STATE OF HAWAII
DEPARTMENT OF TRANSPORTATION
HIGHWAYS DIVISION

SPRINKLER PLAN
PACKAGE NO. 2

PEARL HARBOR INTERCHANGE
F.A.I. PROJ. NO. I-H-1(11)14

SHEET NO. L4 OF 13 SHEETS

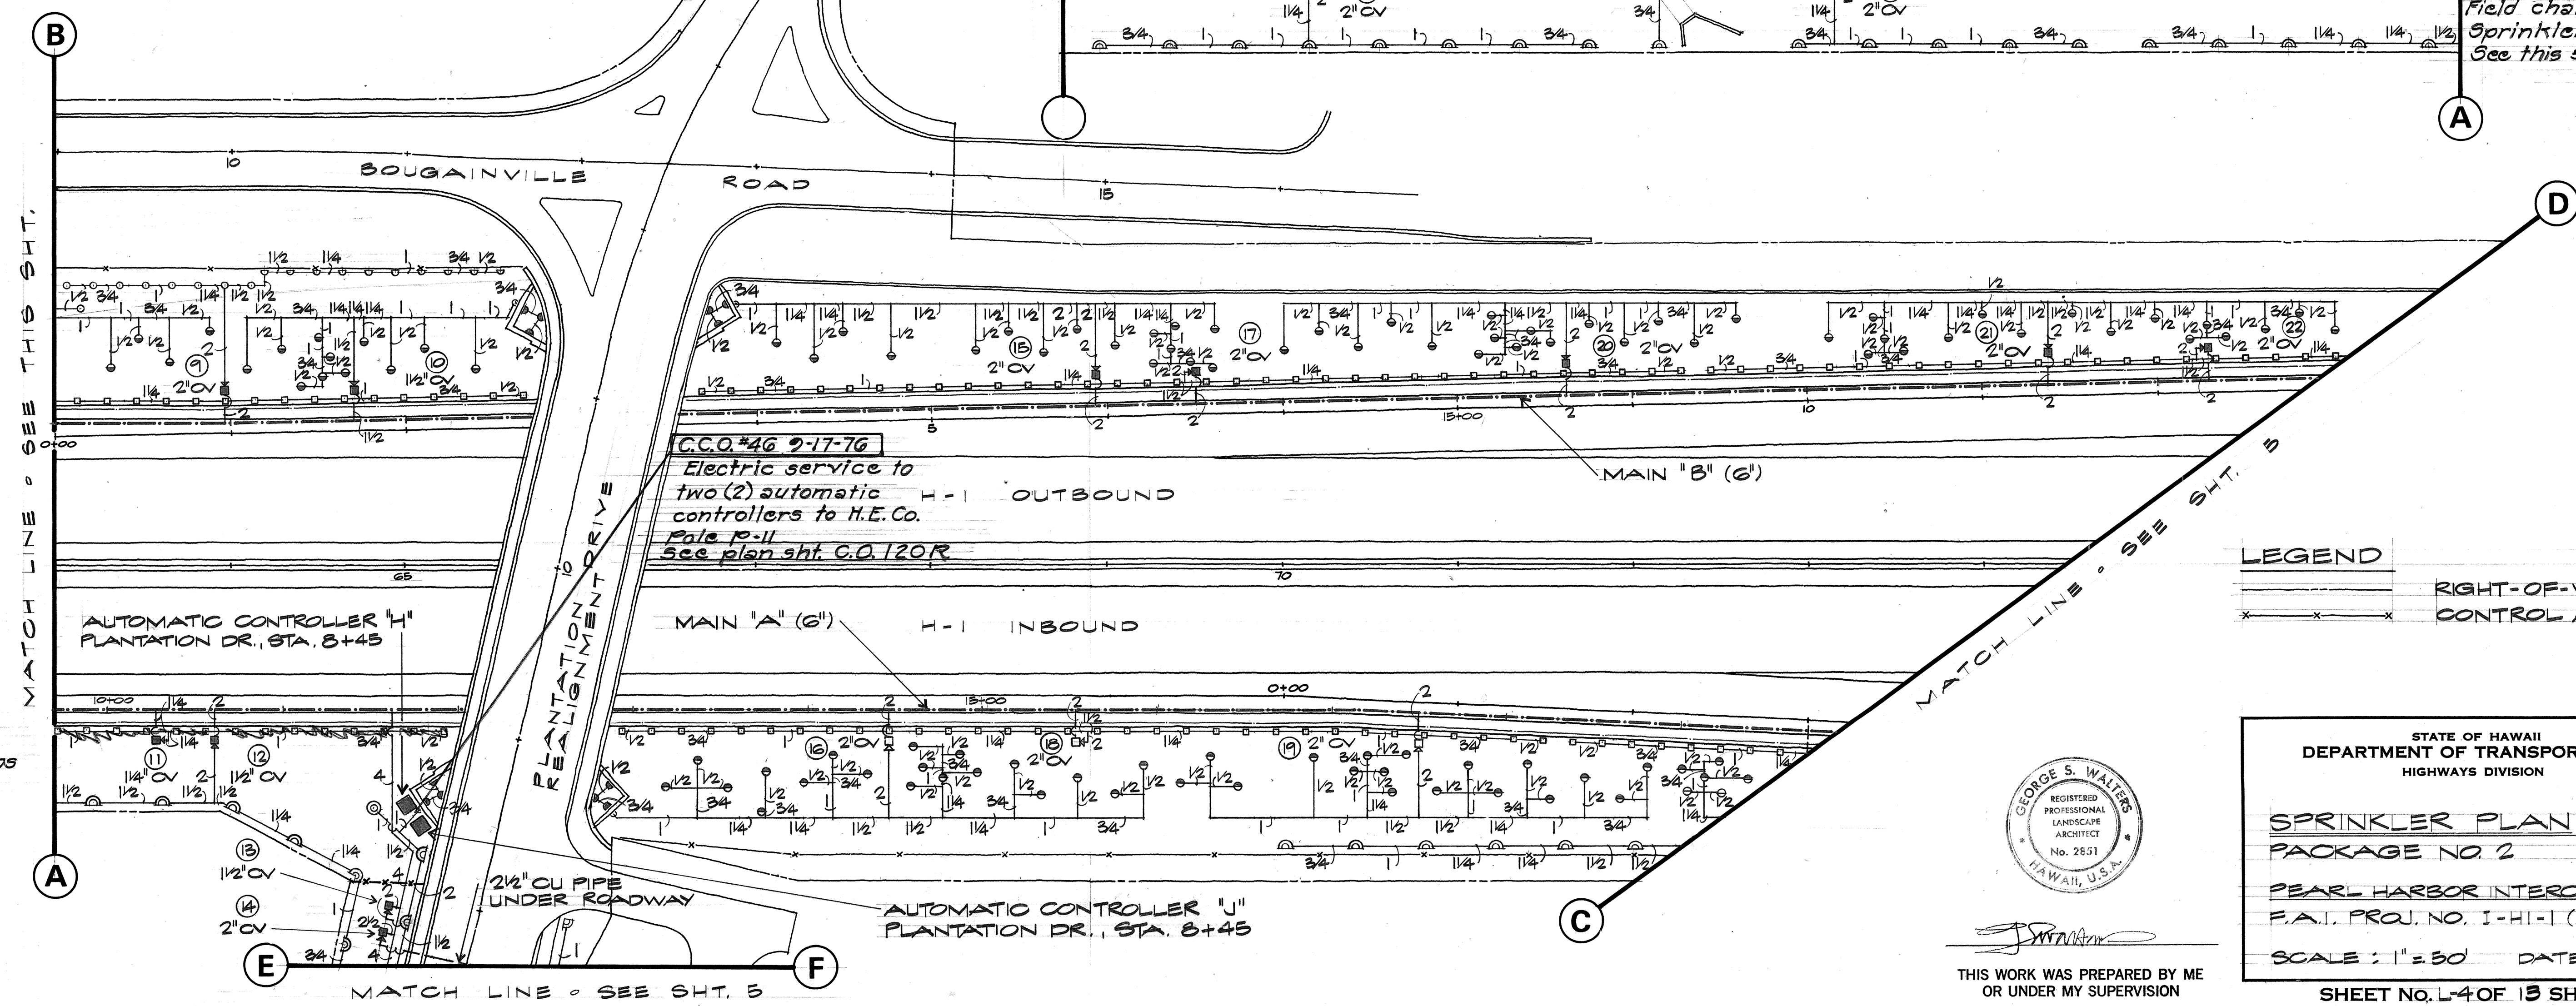
Field Directive
Sept. 7, 1976
Field change of
Sprinkler Systems
See this sheet

Field Directive
Sept. 7, 1976
Field change of
Sprinkler Systems
See this sheet

SHEET NO. 15 OF 13 SHEETS

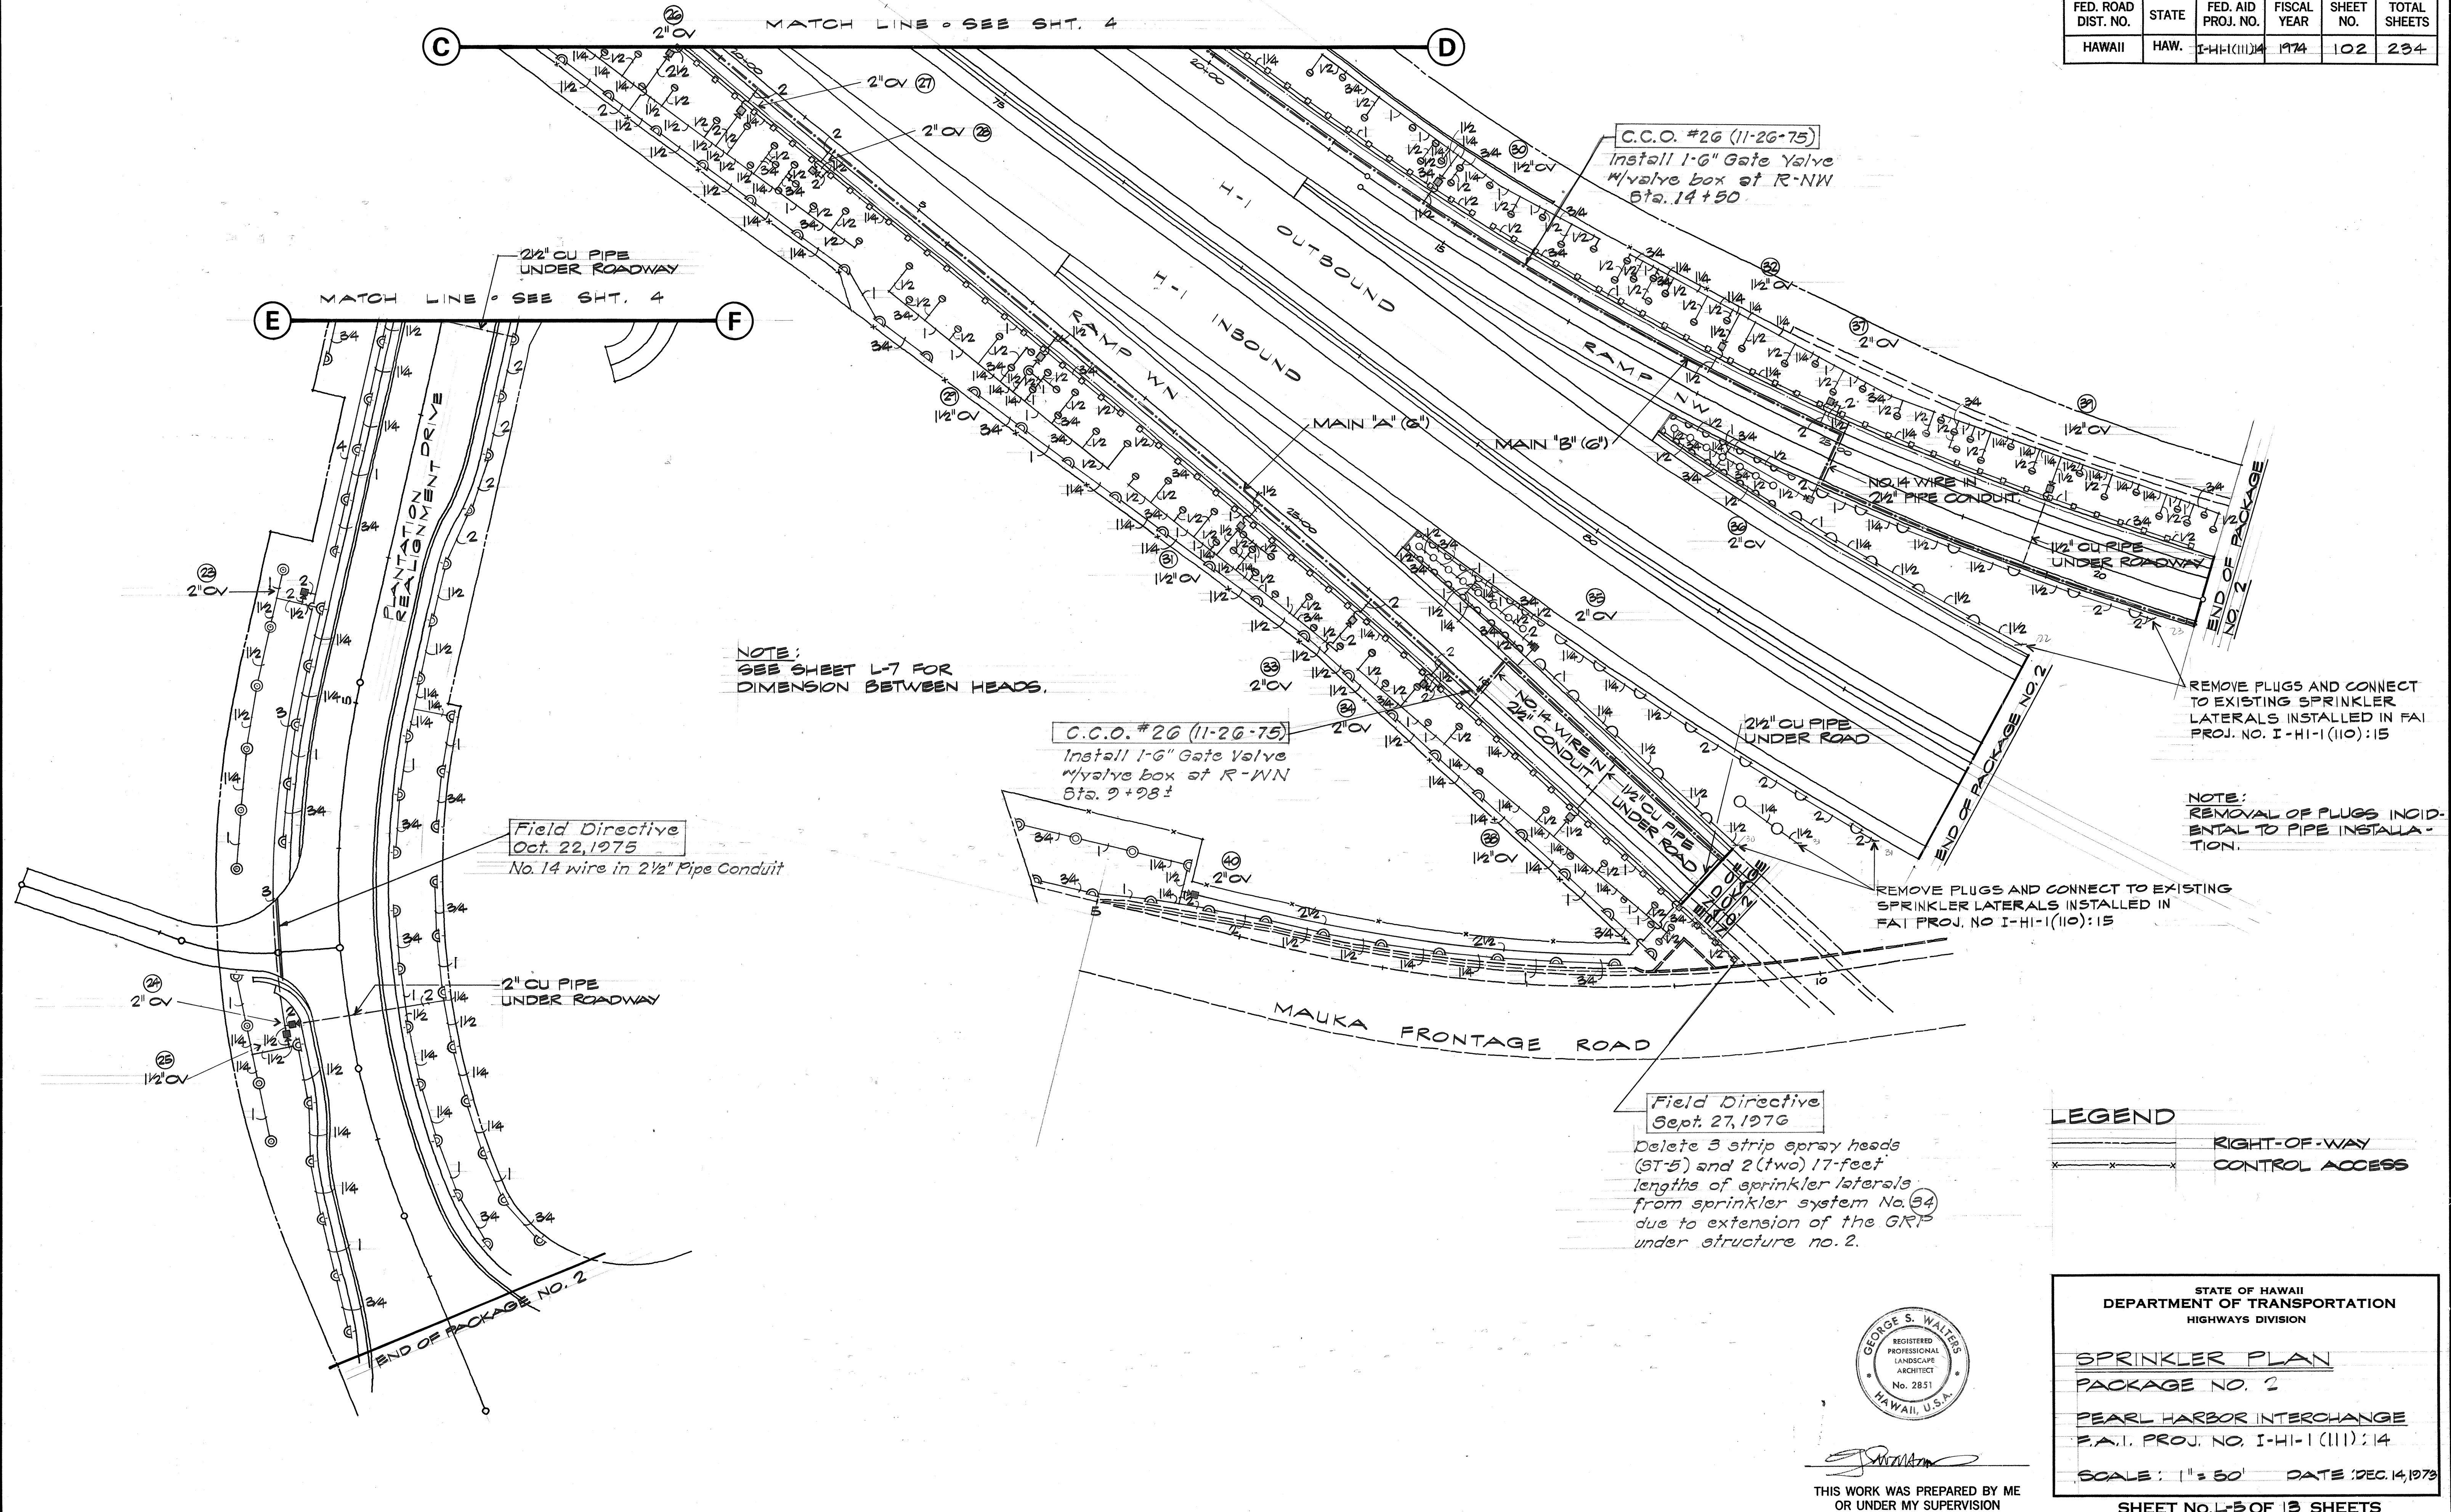
Field Directive
Sept. 7, 1976
See Sht. #101

See Sht. #101 & C.O. 120 R

C.C.O. #46 (2-17-76)

SPRINKLER PLAN
PACKAGE NO. 2
PEARL HARBOR INTERCHANGE
F.A.I. PROJ. NO. I-H-1 (111) 14
SCALE: 1" = 50' DATE: DEC. 14, 1978
SHEET NO. 1-7 OF 13 SHEETS

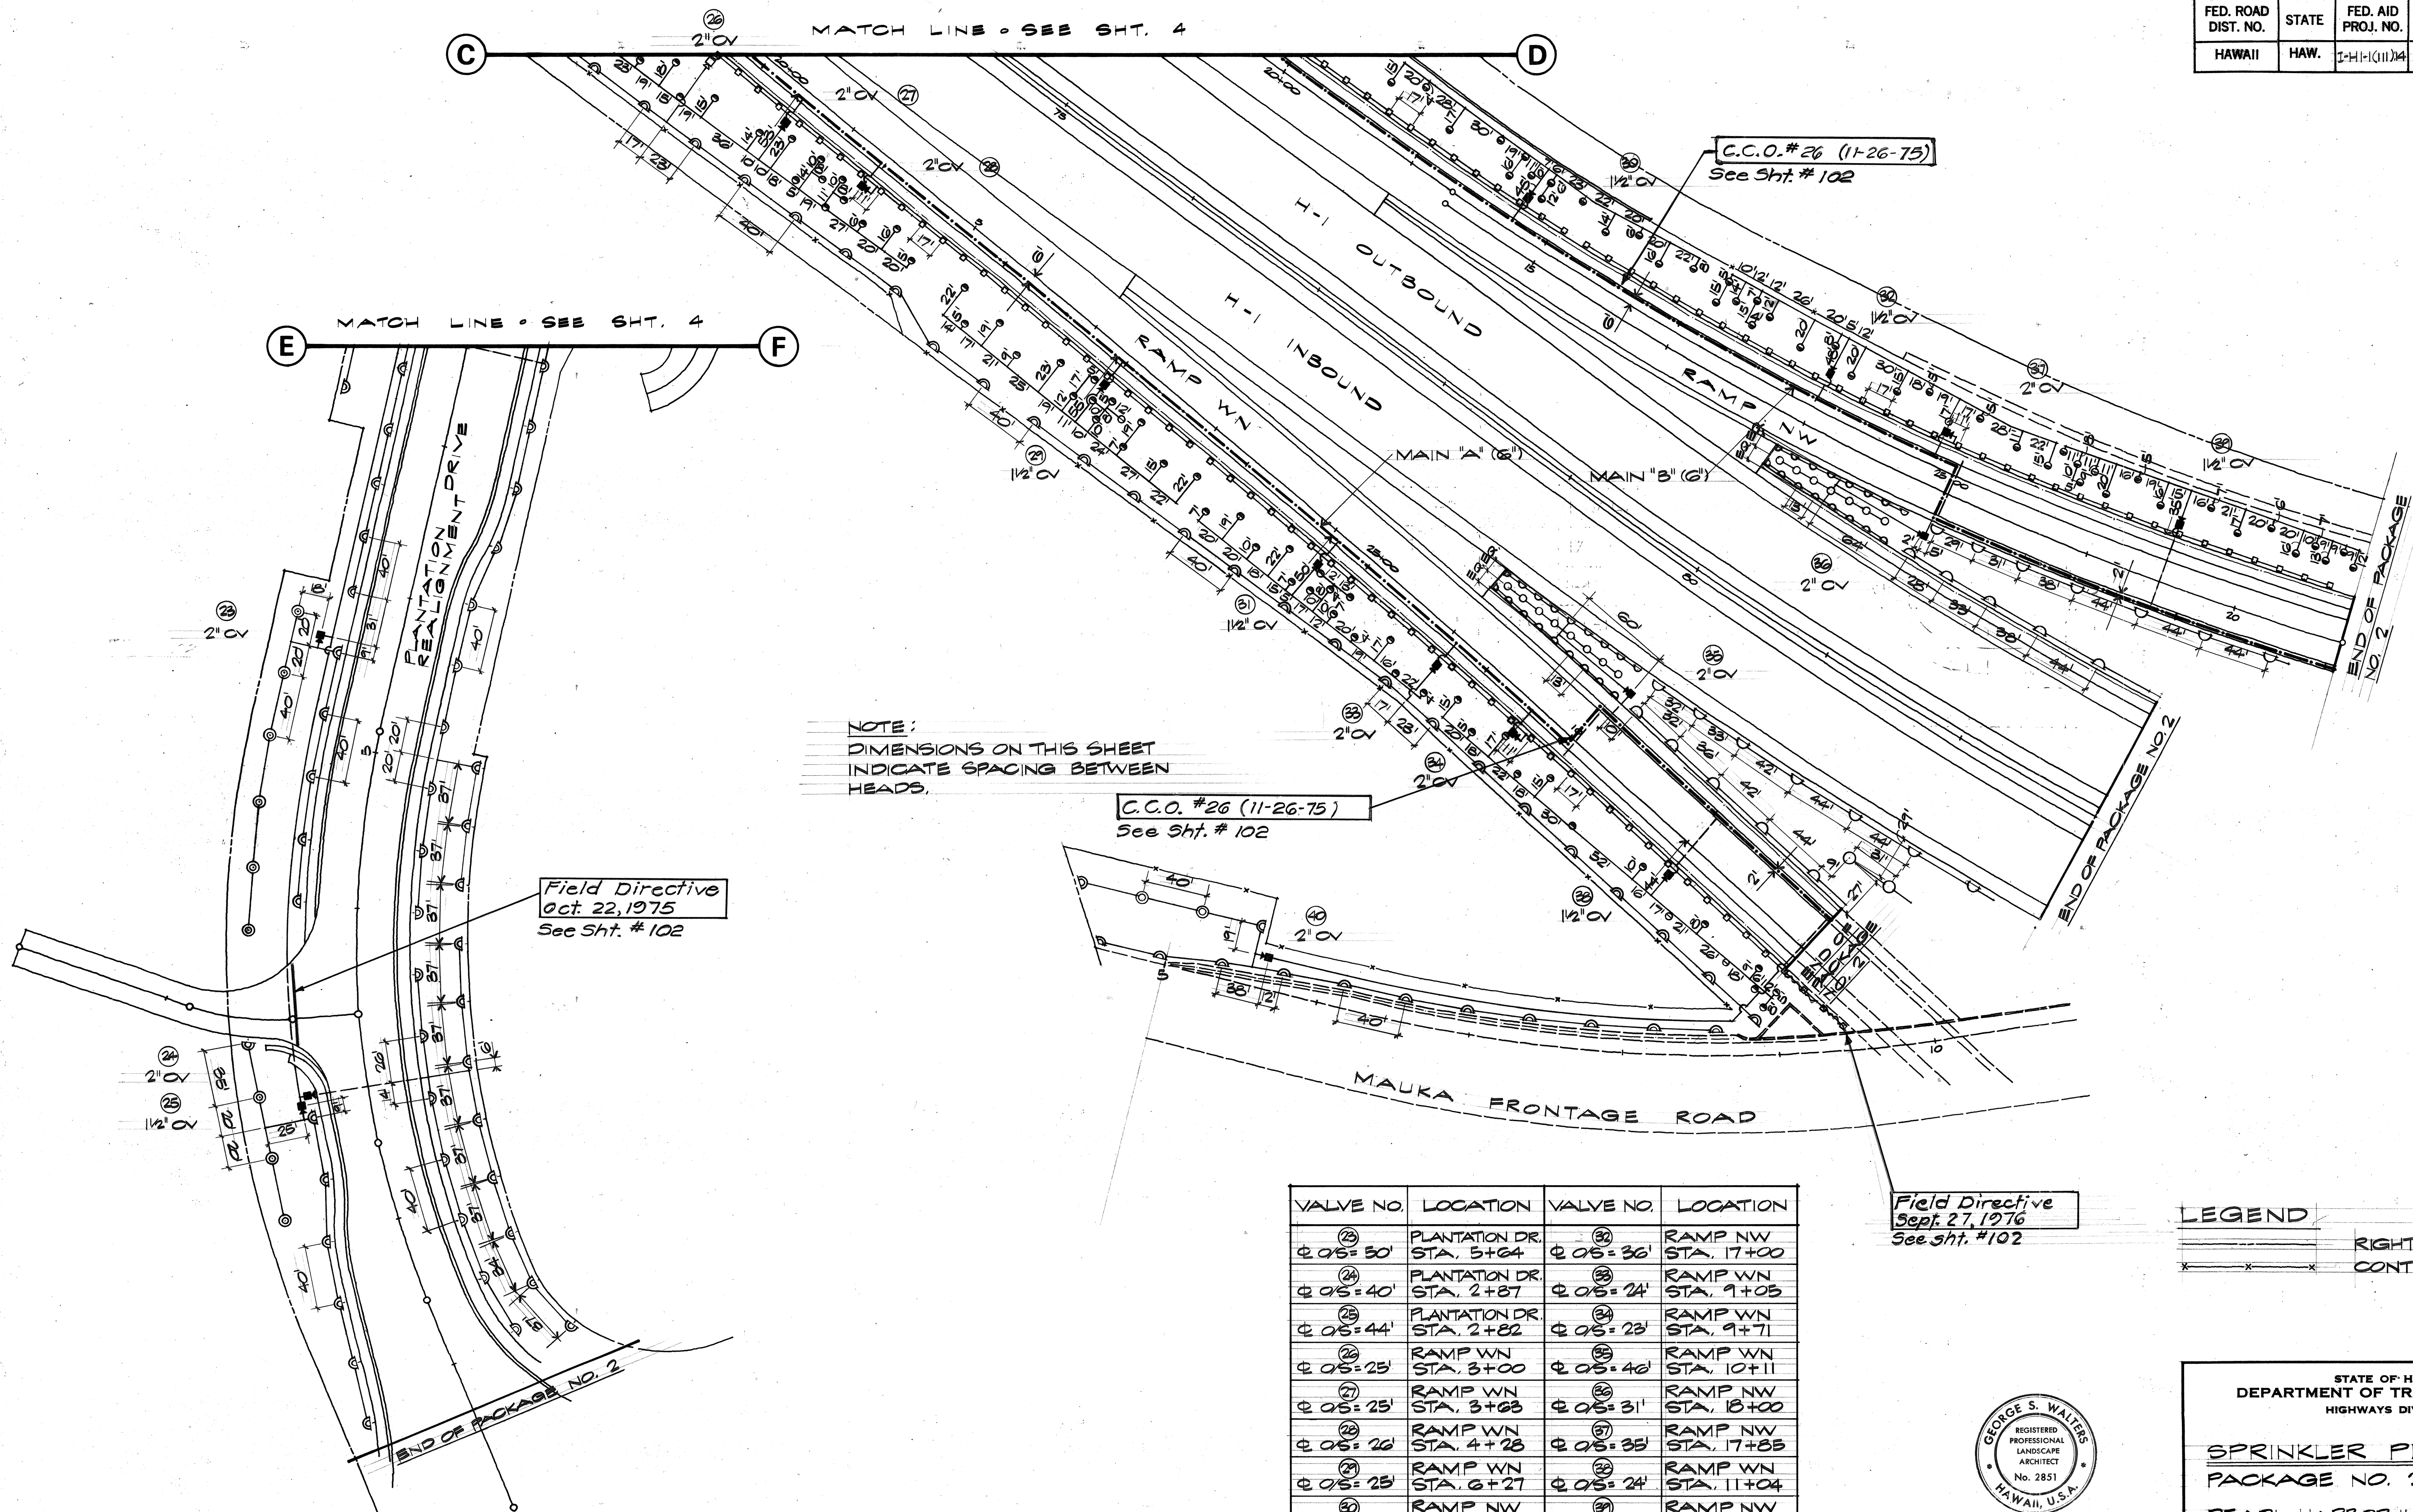
C.C.O. #26 (11-26-75)
See Sht. #102

Field Directive
Oct. 22, 1975
See Sht. #102

Field Directive
Sept. 27, 1976
See Sht. #102
